Manual 19 – Periodic Review

Planning Committee
October 31, 2023

Molly Mooney
Resource Adequacy Planning

Load Drop Estimates for PRD Customers

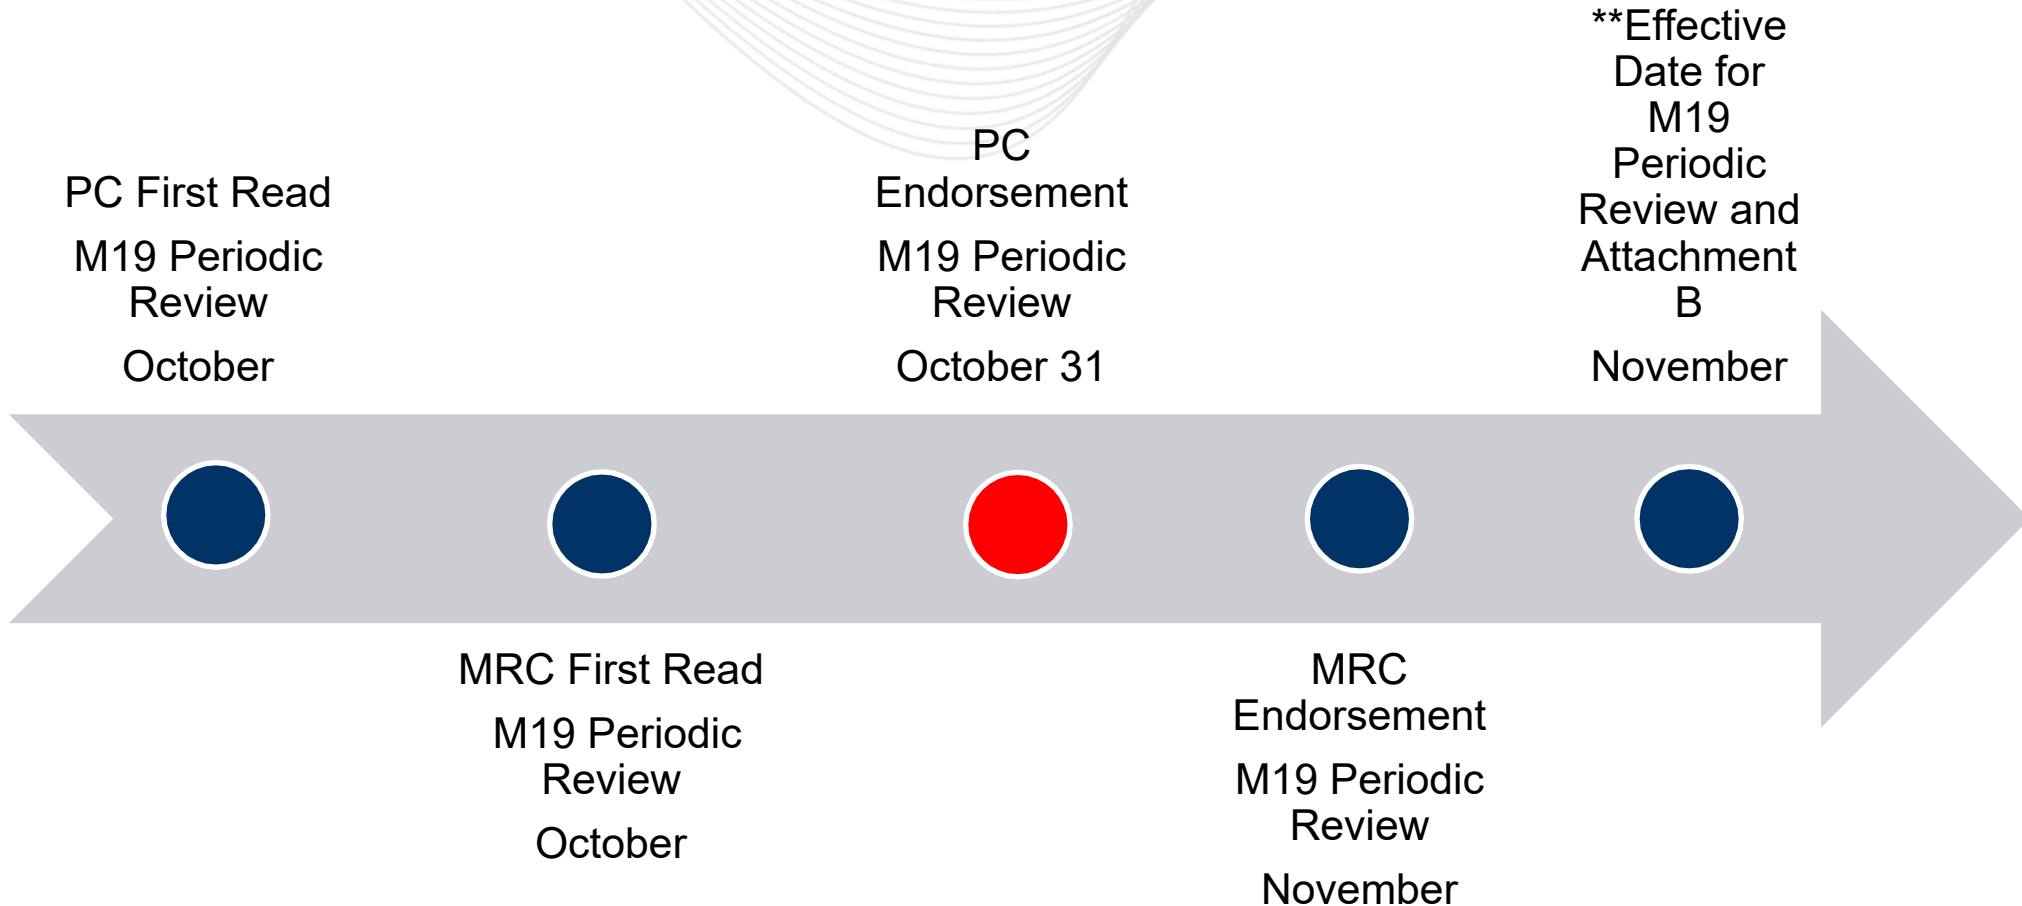
~~For Maximum Emergency Generation hour or a 5CP hour without Maximum Emergency Generation:~~

~~Load Drop Estimate = Peak Load Contribution – (Metered Load * EDC Loss Factor)~~

Load Drop Estimates are applicable to price responsive demand registrations that are used to satisfy a PRD commitment for either RPM or FRR Alternative. Load Drop Estimates are not applicable to Energy Only PRD registrations.
